Patent No.: 6,967,424

Title: ROTOR ASSEMBLY AND STATOR ASSEMBLY FOR AN ELECTRICAL

PURSUANT TO 37 C.F.R. § 1.323

UNITED STATES PATENT AND TRADEMARK OFFICE CERTIFICATE OF CORRECTION

Fig. 1

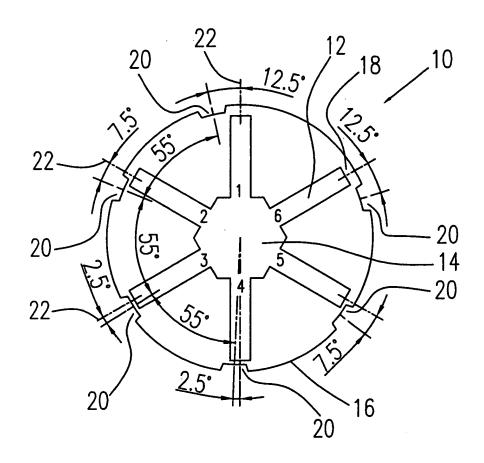
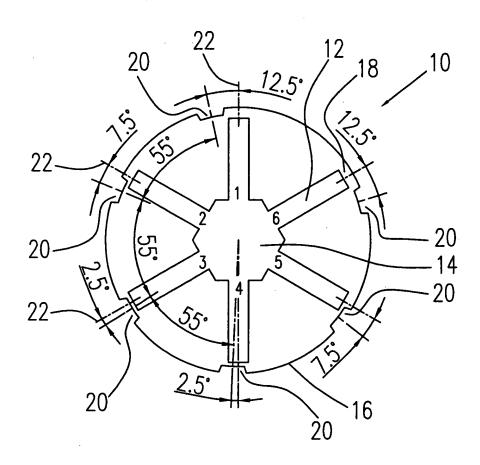
in Figure 1 show the angles indicated as 2.5, 7.5 and 12.5 degrees measured between the center line of the slots 12 and the center line of the shallow notches 20. A corrected Figure 1 is shown on page 2 of 3;

Fig. 2a

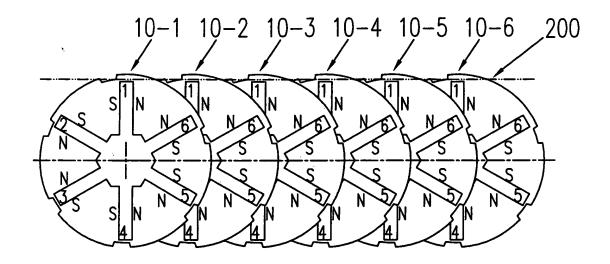
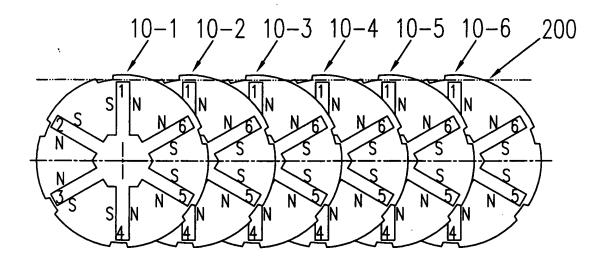
in Figure 2a show groove 200 to be in the same tangential position with regard to the slots of laminations 10-1, 10-2, 10-3, 10-4, 10-5 and 10-6. A corrected Figure 2a is shown on page 3 of 3; and

Fig. 2b

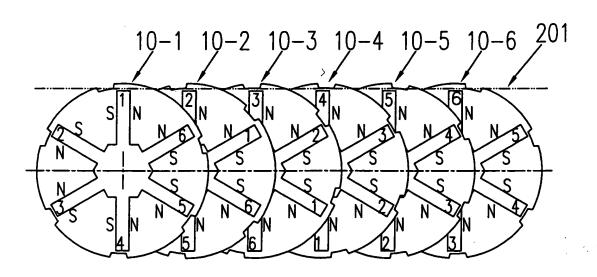
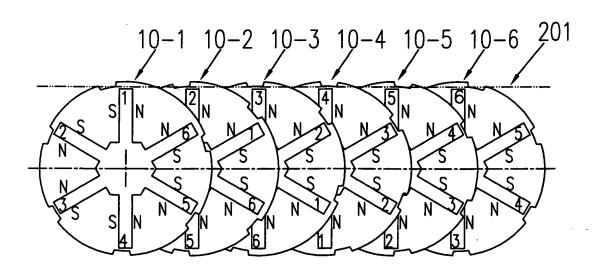
in Figure 2b show groove 201 to be in the same tangential position with regard to the slots of laminations 10-1, 10-2, 10-3, 10-4, 10-5 and 10-6. A corrected Figure 2b is shown on page 3 of 3.
